NUMBER
DEP16573

LINE	QUANTITY	UOP	CAT. NO.	ITEM NUMBER	UNIT PRICE	AMOUNT
				ADDENDUM NO.01		
				THIS ADDENDUM IS ISSUED TO MODIFY THE ORIGINAL SOLICITATION PER THE ATTACHED DOCUMENTATION.		
0001	1	JB		962-73		
				RECLAMATION: RESTORATION OF LAND & OTHER PROPERTIES		
				***** THIS IS THE END OF RFQ DEP16573 ***** TOTAL:

Addendum Number: 01

DEP16573
Vickers Branch (Butcher) Drainage
Addendum #1

Item 22: WVDOH Traffic Control Plan A4 for Site 3 is shown below.

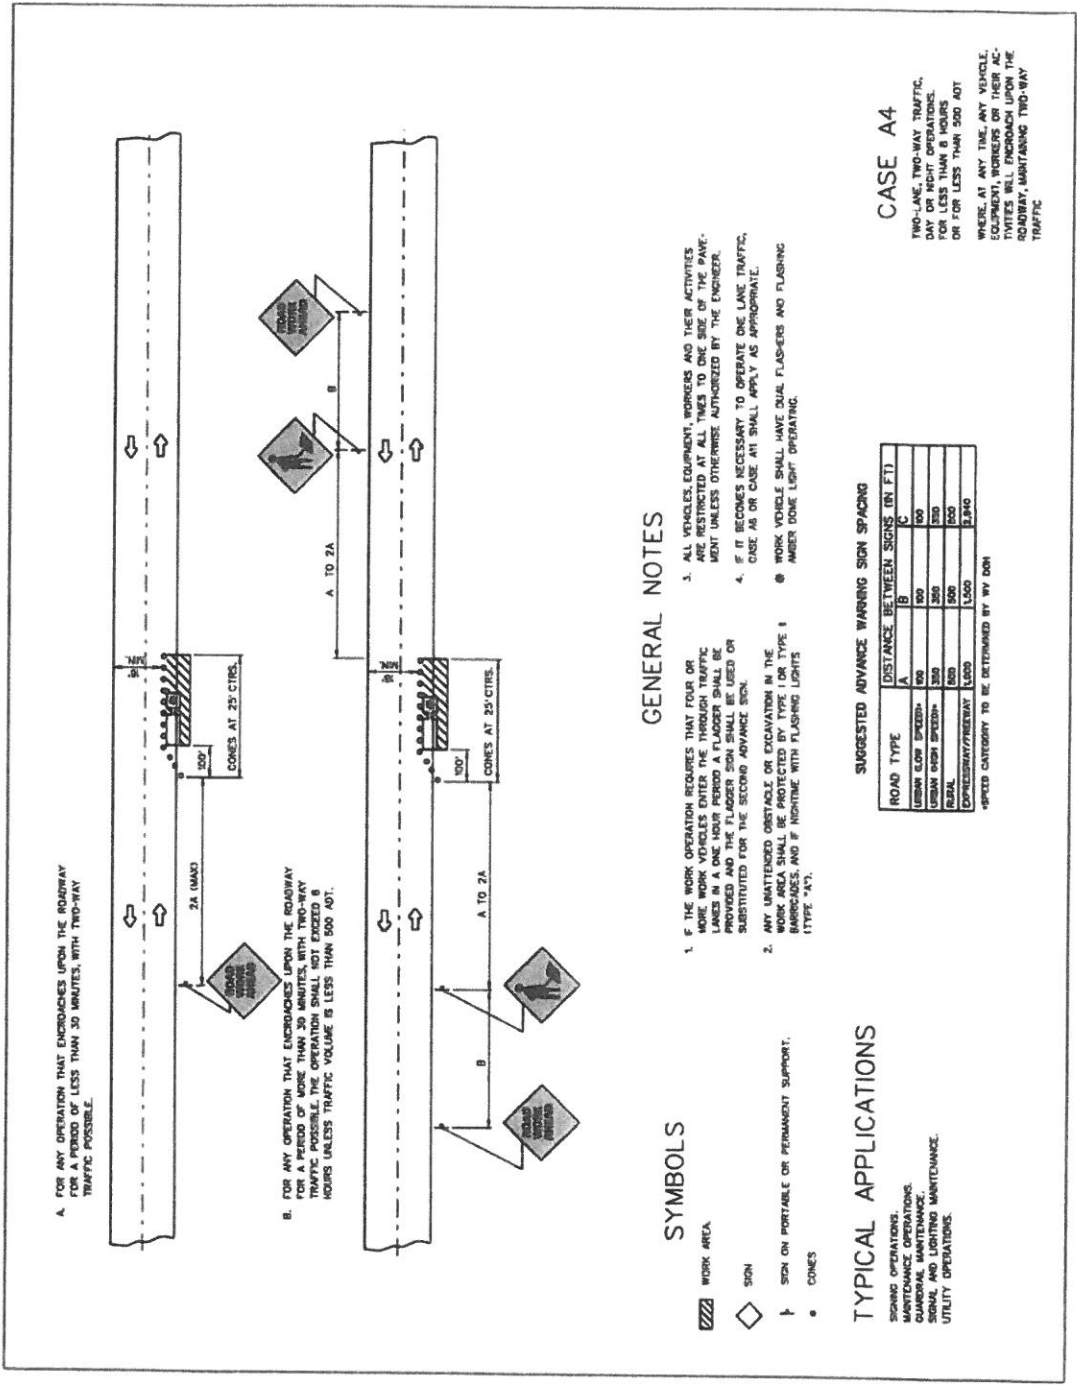
- Item 6: Statement: Since site 3 requires work on a county route (Fox Den Road, CR 4/3), a WVDOH permit was obtained, and traffic control is required. The approved traffic control plan is WVDOH Case A4, and is included at the end of this addendum as Item 22.
